PCB		
Title		
ErgoMedia R7000		
Size		
B		
Document Number		
CKT:21010018101		
Rev		
2		
Date:		
Thursday, August 04, 2005		
Sheet		
1		
of		
1

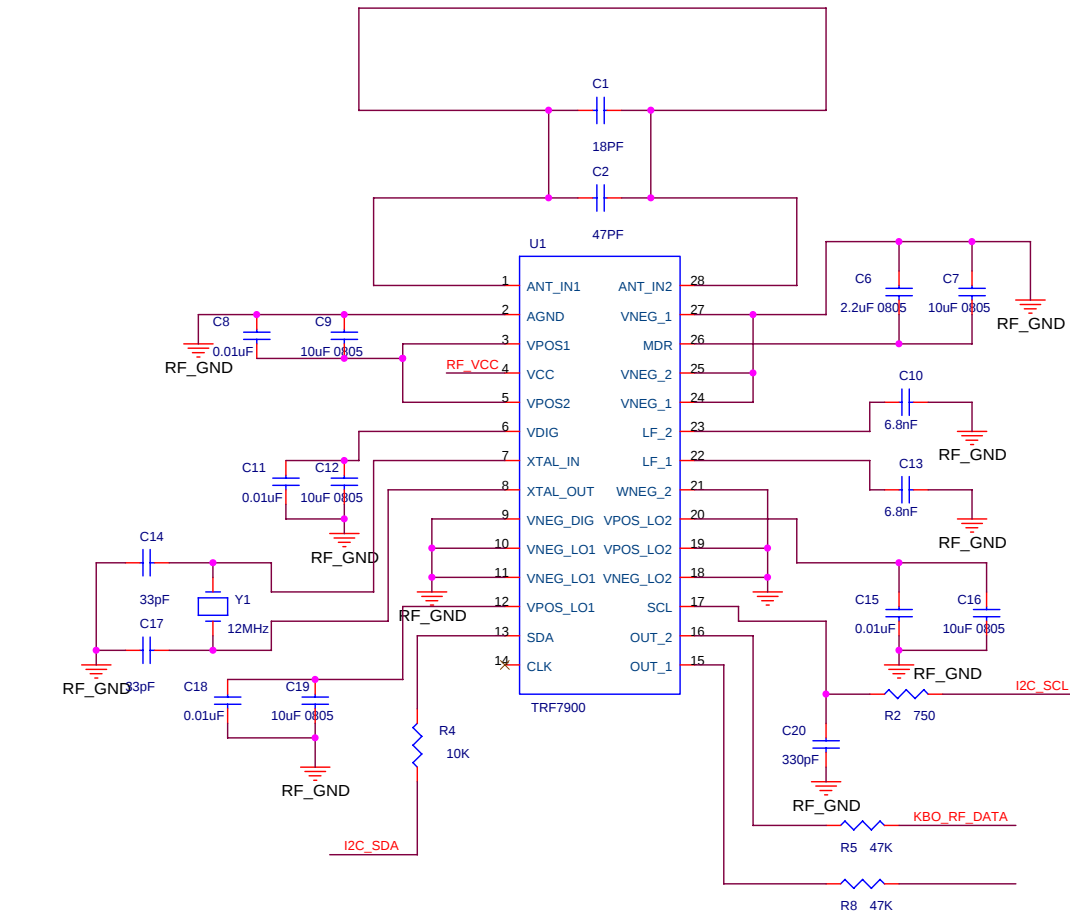
Date:2005-5-5
修改J1 规格
R3 , R6 拿掉
C8 改成 0603
C12,C19 改成 0805

Date:2005-5-23
Rev:3
Add L3
